# Work Order ID 105213

Item Name: Crosstube Assembly, Mid All

DART AEROSPACE LTD HAWKESBURY, ONTARIO, CANADA	
DRAWING NO. D206-667-247	REV. A SHEET 1 OF 4
TITLE CROSSTUBE ASS'Y (206L MID AFT)	SCALE NTS

DRAWING NO. D206-667-247	TITLE CROSSTUBE ASS'Y (206L MID AFT)	REV. A	DART AEROSPACE LTD ENGINEERING ORDER		D.E.O. NO. D206-667-247-A-1	SHEET NO. SHEET 1 OF 1	SCALE NTS
DRAWN 97	CHECKED ASS	MFG. APPR. KDS	APPROVED JMD	DE APPR. H			
DATE 11.07.15	DATE 11.07.20	DATE 11.07.21	DATE 11/07/21	DATE 11.07.21

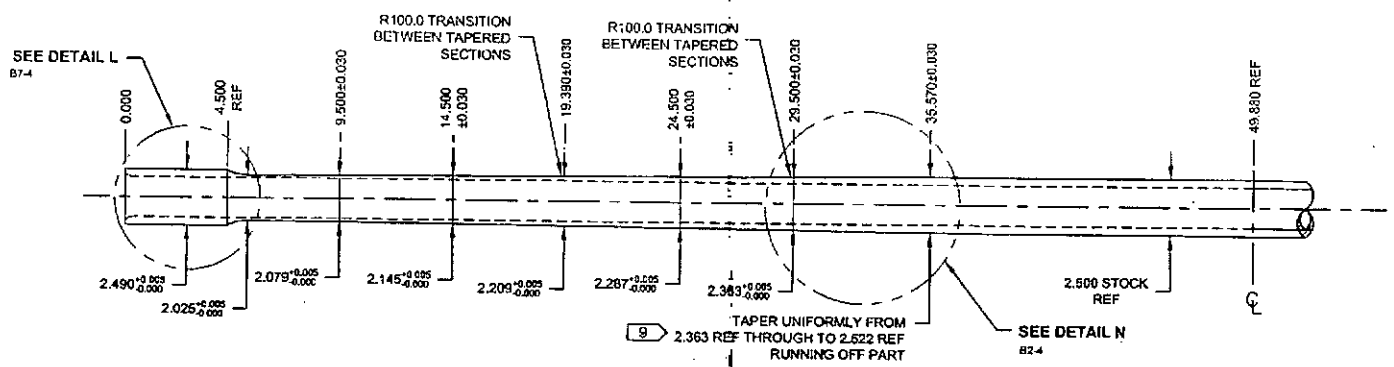
**PURPOSE:**

REPLACE MAGNOBOND WITH PROSEAL.

IS:

Item	Qty -247	Part Number	Description
9	A/R	PROSEAL 890 B-2	SEALANT, AMS-S-8802 CLASS B-2

WAS:

9	A/R	MAGNOBOND 6398	ROCKWELL SPECIFICATION RBO-120-023 ADHESIVE (TEXTRON/BELL SPEC. 299-947-100, TYPE II, CLASS 2 ADHESIVE)
---	-----	----------------	---

NOTE 12 &amp; 15, SHEET 1 IS AMENDED AS FOLLOWS:

IS:

- 12) TO INSTALL D2892-1 SUPPORT: ABRASE MATING SURFACE OF SUPPORT AND CROSSTUBE WITH 180-GRIT SANDPAPER AND REMOVE RESIDUE WITH MEK (OR EQUIVALENT). APPLY A 0.04" TO 0.07" THICK LAYER OF PROSEAL 890 CLASS B-2 (OR AMS-S-8802 CLASS B-2) SEALANT TO MATING SURFACE OF SUPPORT.
- 15) TORQUE CLAMPS 80 TO 100 IN-LB. ENSURE AT LEAST 1.5 THREADS SHOWING IN SAFETY AND THAT NUT HAS NOT BOTTOMED-OUT AFTER TORQUING. **PRIOR TO PACKAGING, RE-CHECK TORQUE ON CLAMPS AFTER PROSEAL 890 SEALANT HAS CURED FOR 72 HOURS.**

WAS:

- 12) INSTALL D2892-1 SUPPORT USING 0.03" TO 0.06" THICK LAYER OF MAGNOBOND 6398 PER QSI 015. LET. CURE FOR 12 HOURS AFTER INSTALLATION AND PRIOR TO PACKAGING.
- 15) TORQUE CLAMPS 80 TO 100 IN-LB. ENSURE AT LEAST 1.5 THREADS SHOWING IN SAFETY AND THAT NUT HAS NOT BOTTOMED-OUT AFTER TORQUING.
